Title & Document Type: HP 339A Operating and Service Manual

Manual Part Number: 00339-90001

MODEL 339A

DISTORTION MEASUREMENT SET

Figure 8-16. Auto Set-Level and Meter Circ
8-19/1

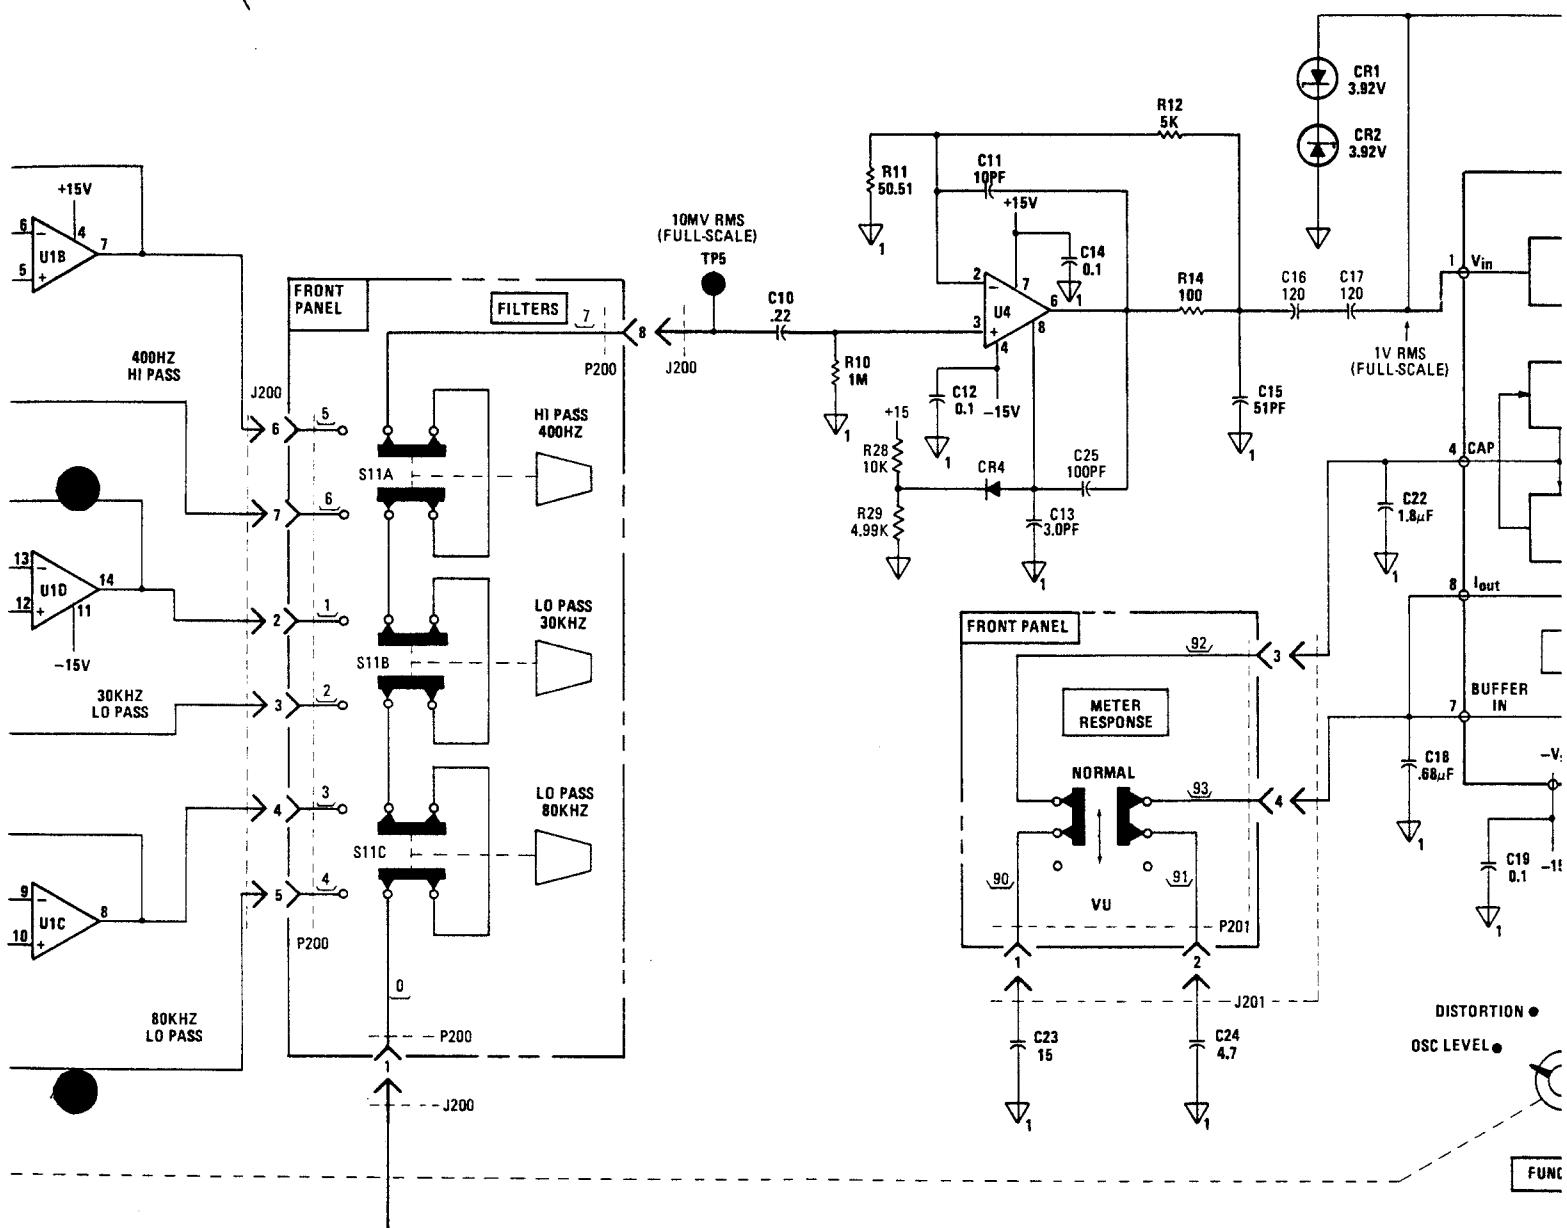
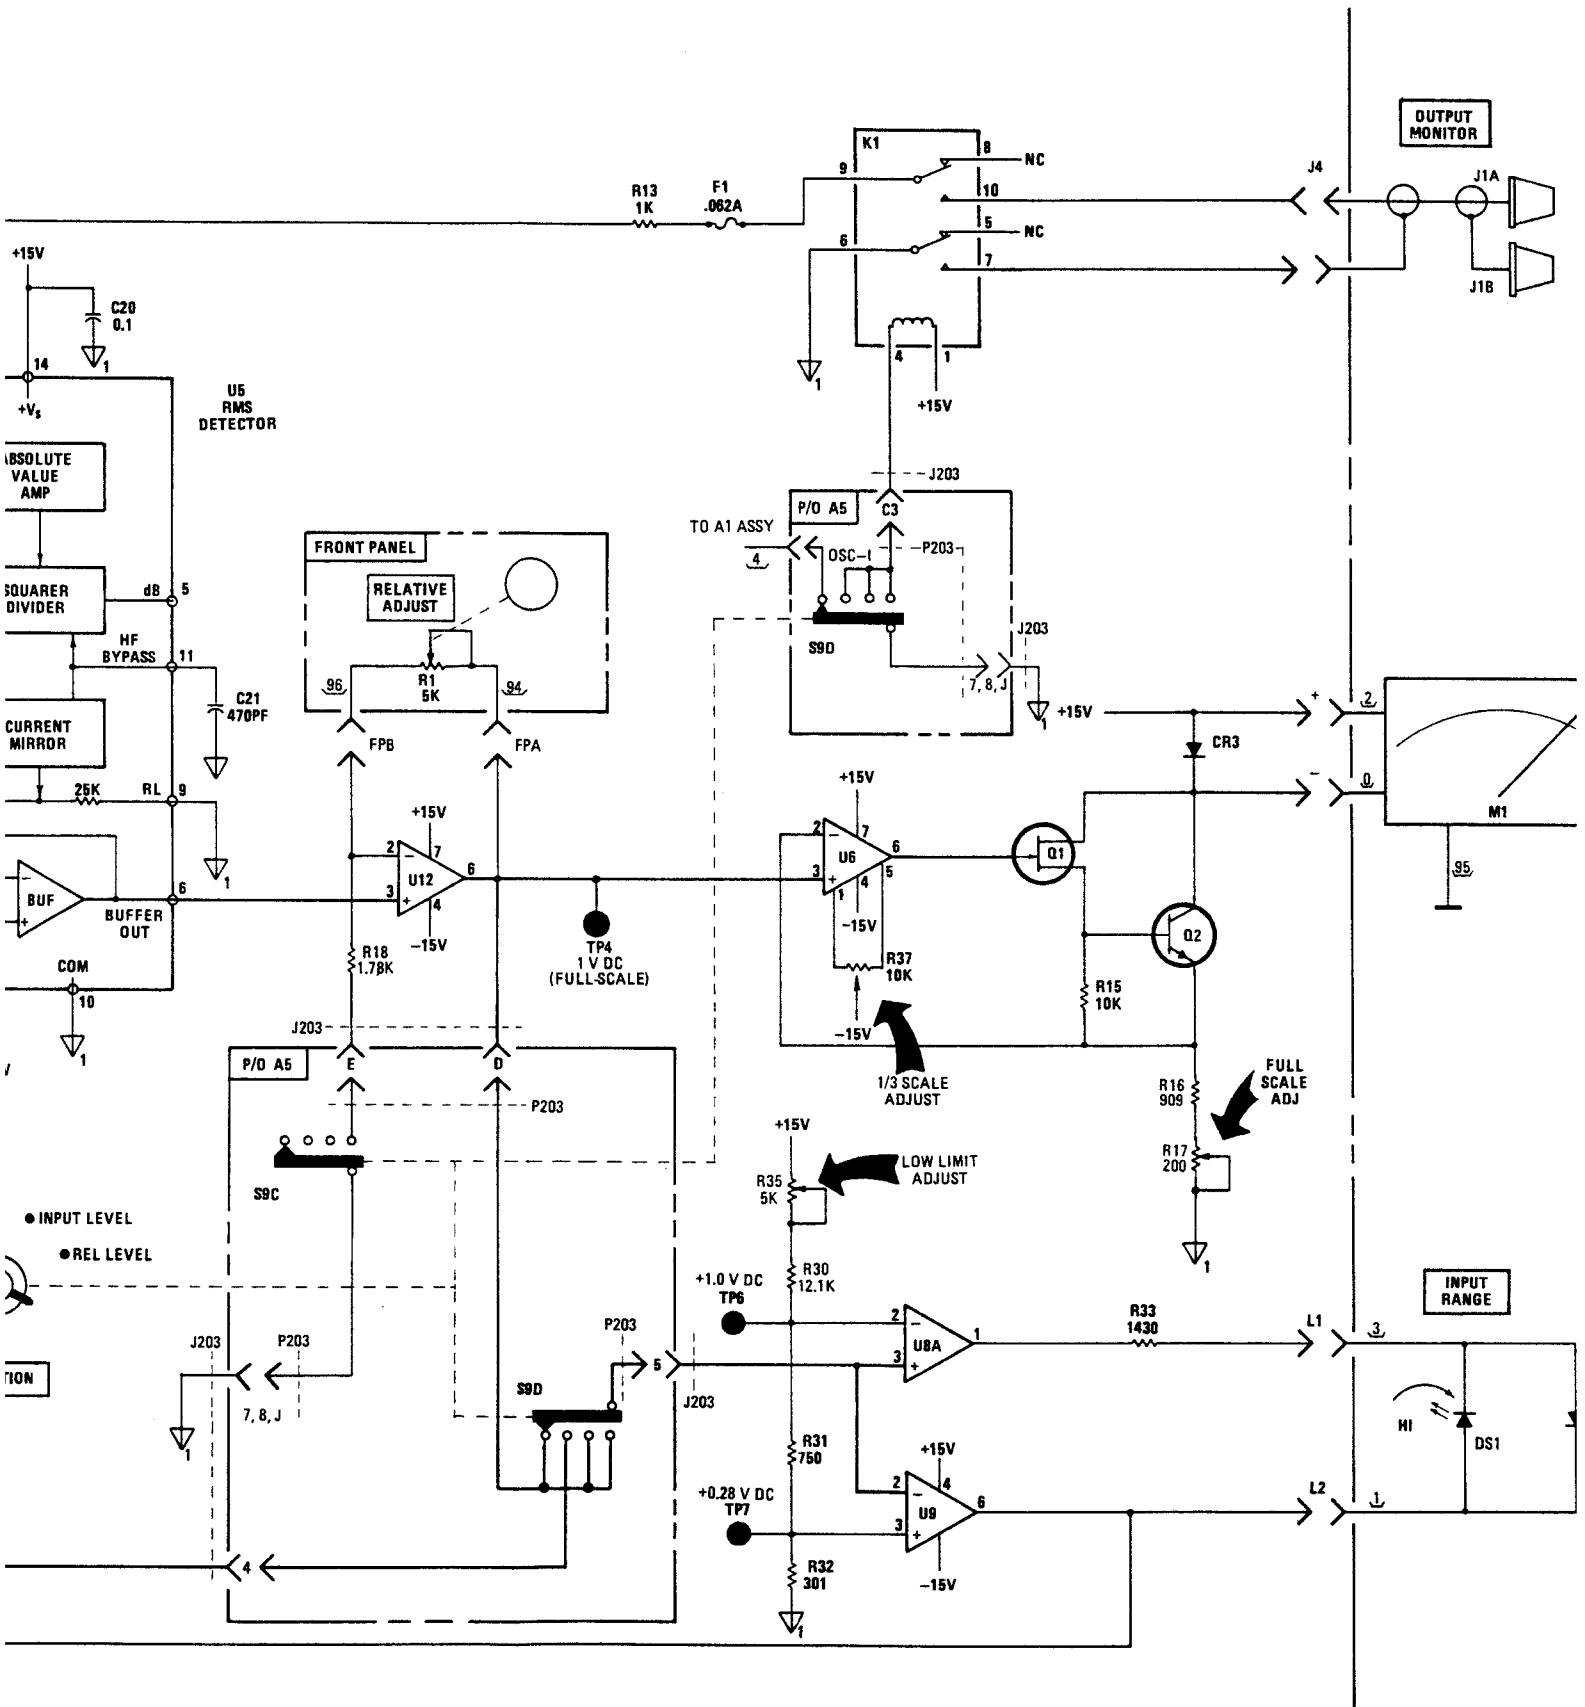
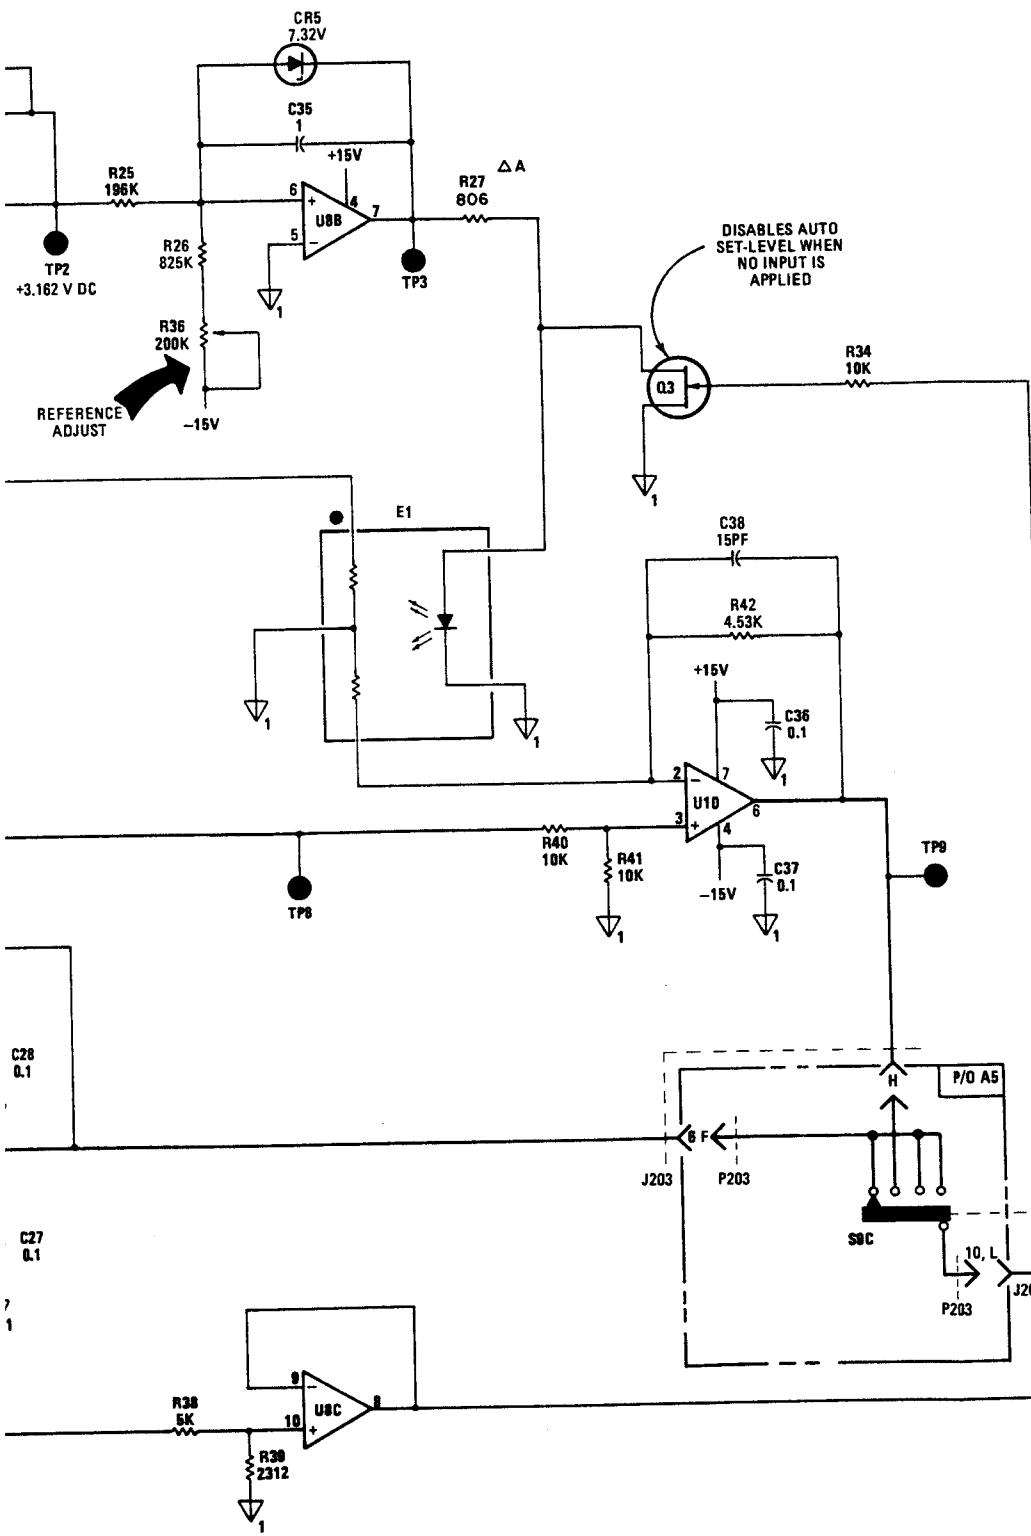
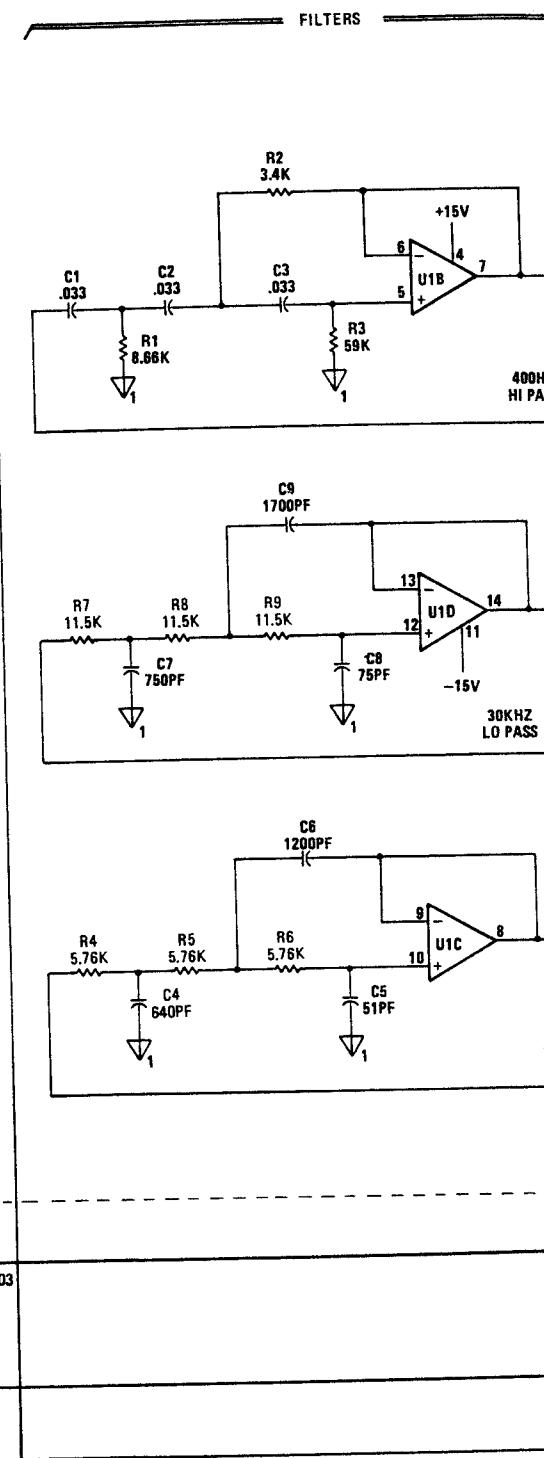
Page 8-19/8-20, Figure 8-16. Change the value of resistor R22 from 100 Ω to 200 Ω on the schematic diagram. Add resistor R43 as shown in Figure 2.

Page 8-19/8-20, Figure 8-16. Delete C21 from the schematic.

Page 8-19/8-20, Figure 8-16. Change the schematic value of C13 from 3pF to 1pF.

Page 8-19/8-20, Figure 8-16. Delete schematic symbols, values, and designators for C11 and C13.

Page 8-19/8-20, Figure 8-16. Change the value of C4 from 640pF to 470pF and that of C5 from 51pF to 68pF.

Page 8-19/8-20, Figure 8-16. Change the value of C4 from 470pF to 500pF and that of C5 from 68pF to 62pF.

Page 8-19/8-20, Figure 8-16. Change the value of C15 from 51pF to 100pF.

Page 8-19/8-20, Figure 8-16. Change the value of R6 from 5.76kΩ to 5.49kΩ.

Page 8-19/8-20, Figure 8-16. Change the schematic value of R16 from 909 to 750 and that of R17 from 200 to 500.
